Access Compliance Report

Public Rights-of-Way

Intersection ID: 44723	Main Street: PROSPERITY_CHURCH_RD	Cross Street: JOHNSTON_OEHLER_RD	Location: SE
ADA ID: 4AF031162539	Ramp Type: IslandPerp	Initial Pass/Fail: Fail	Overall Compliance: No
Severity Score: 12.5			
Codes/Mitigation Info/Possible Solution		Field Measurements/Component Compliance

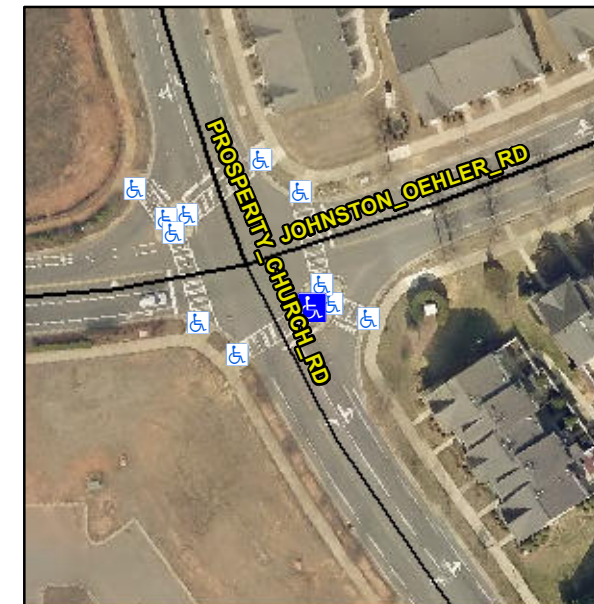
R304.2.2

Compliance	Description	Data	Compliance	Description	Data
N/A	Ramp Length (in)	48.0	No	Ramp Slope (%)	9.6
Yes	Ramp Width (in)	48.0	Yes	Ramp XSlope (%)	1.2
N/A	Flare Type LT	N/A	N/A	Flare Type RT	N/A
N/A	Flare Slope LT (%)	N/A	N/A	Flare Slope RT (%)	N/A
N/A	Flare Traversable LT?	N/A	N/A	Flare Traversable RT?	N/A
N/A	Landing Length (in)	N/A	N/A	DWS Provided?	N/A
N/A	Landing Width (in)	N/A	N/A	DWS Contrast?	N/A
N/A	Landing Slope (%)	N/A	N/A	DWS Length (in)	N/A
N/A	Landing X Slope (%)	N/A	N/A	DWS Full Width?	N/A
N/A	Landing Curb? (Y/N)	N/A	N/A	DWS Offset (in)	N/A
N/A	Shared Landing?	N/A			
N/A	Gutter Ponding?	N/A	N/A	Gutter Slope (%)	N/A
N/A	Gutter Lip Ht (in)	N/A	N/A	Gutter X Slope (%)	N/A
N/A	Painted X Walk1?	Yes	N/A	Painted X Walk2?	N/A
	X Walk 1 Direction	To SW		X Walk 2 Direction	N/A
N/A	X Walk 1 Width (in)	112.0	N/A	X Walk 2 Width (in)	N/A
	X Walk 1 Slope (%)	2.2		X Walk 2 Slope (%)	N/A
	X Walk 1 X Slope (%)	1.6		X Walk 2 X Slope (%)	N/A

Remove & Replace Entire Ramp.

\$ 3400.00
